**PARAVION TECHNOLOGY, INC.  
2001 AIRWAY AVENUE  
FT. COLLINS, COLORADO 80524**

REPORT NO. PR-407PX-900M

INSTALLATION INSTRUCTIONS

407PX-100 PEDAL EXTENSION INSTALLATION

Figure 1

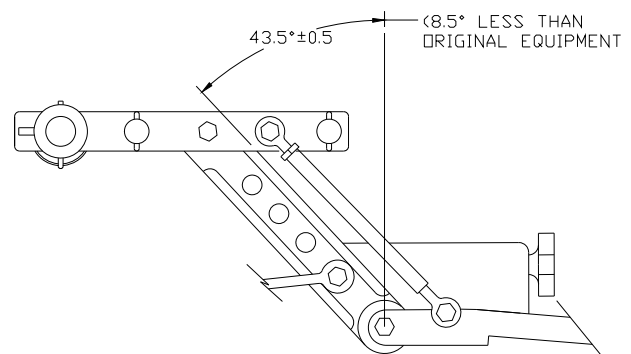
You must have complied with applicable revision of BHT ASB# 407-99-33 except as follows: Indicated pedal angle for Paravion Pedal Extension Kit is  $8.5^\circ$  less than the Bell standard pedal installation, when measured from the vertical plane (Reference: Figure 1).

**Figure 1**

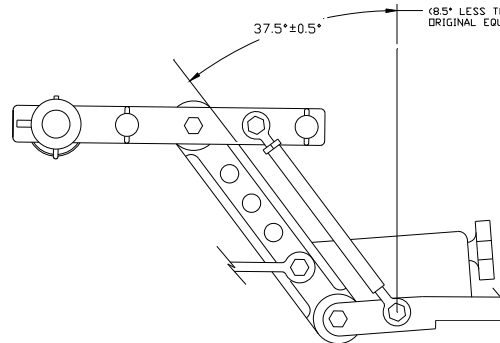
Comply with applicable revision of AD2000-14-16 except as follows:  
Indicated pedal angle for Paravion Pedal Extension Kit is 8.5° less than the Bell standard pedal installation, when measured from the vertical plane (Reference: Figure 1).
